PRODUCT SUPPORT BULLETIN BULLETIN NO. 341

MACHINE: **All NORDCO Spike Drivers**

SUBJECT: **Hex Head Breakaway Pusher Block Bolt – 19104550**

**RH Pusher Block Assembly – 96410450
(LH 96410493 Opposite)**

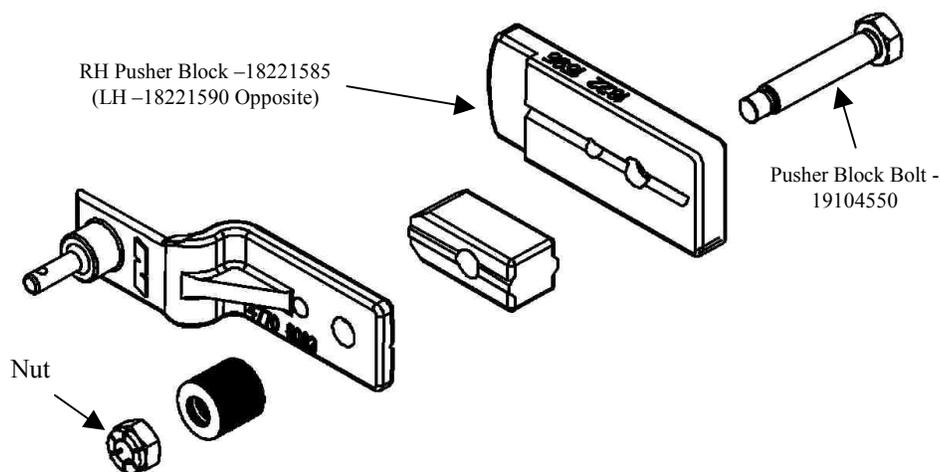
A **Hex Head Bolt, p/n 19104550**, has replaced the Socket Head Shoulder Bolt, p/n 19485220, originally used on the **Breakaway Pusher Block Assemblies, p/n 96410450 and 96410493**.

The **Pusher Blocks, p/n 18221585 and 18221590**, have been changed to incorporate a hexagonal recess for the bolt head. The Hex Head Bolt will fit into this recess and will prevent the bolt from turning while tightening the nut. This will allow quicker changing of the pusher block because no Allen wrench is required to hold the bolt while the nut is tightened. The Socket Head Shoulder Bolt can still be used with these pusher blocks if desired. However, the Socket Head Shoulder Bolt will not be furnished after existing inventory is depleted.
